# SEQUOYAH NUCLEAR PLANT, UNIT 2

# AMENDMENT TO FACILITY OPERATING LICENSE

Amendment No. 138 License No. DPR-79

# ATTACHMENT TO LICENSE AMENDMENT NO. 138

Figure 3.4.2. Sequoyah Unit 2 Reactor Coolant System Heatup Limitations Applicable up to 16 EFPY

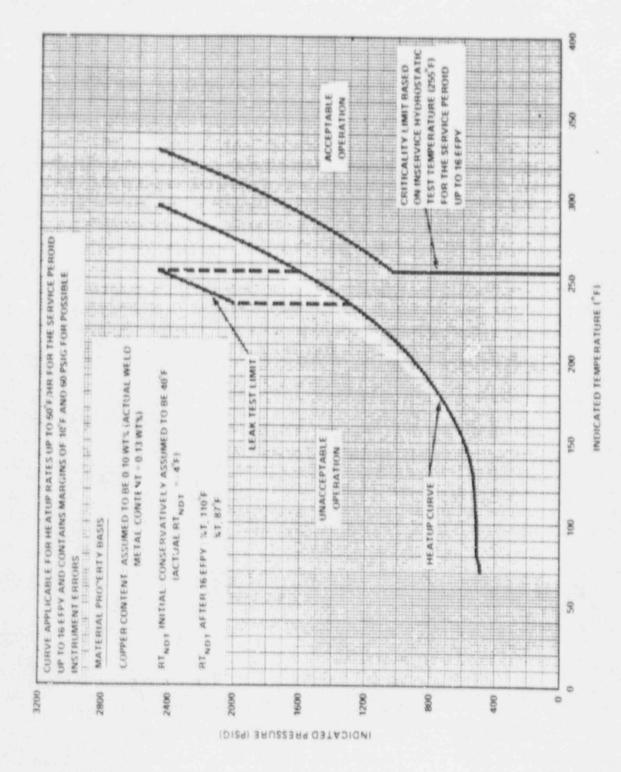
- 3.4.9.1 The Reactor Coolant System (except the pressurizer) temperature and pressure shall be limited in accordance with the limit lines shown on Figures 3.4-2 and 3.4-3 during heatup, cooldown, criticality, and inservice leak and hydrostatic testing with:
  - a. A maximum heatup of 100°F in any one hour period.
  - b. A maximum cooldown of 100°F in any one hour period.
  - c. A maximum temperature change of less than or equal to 5°F in any one hour period during inservice hydrostatic and leak testing operations above the heatup and cooldown limit curves.

- 4.4.9.1.1 The Reactor Coolant System temperature and pressure shall be determined to be within the limits at least once per 30 minutes during system heatup, cooldown, and inservice leak and hydrostatic testing operations.
- 4.4.9.1.2 The reactor vessel material irradiation surveillance specimens shall be removed and examined, to determine changes in material properties in accordance with 10 CFR 50. Appendix H. The results of these examinations shall be used to update Figures 3.4-2 and 3.4-3.
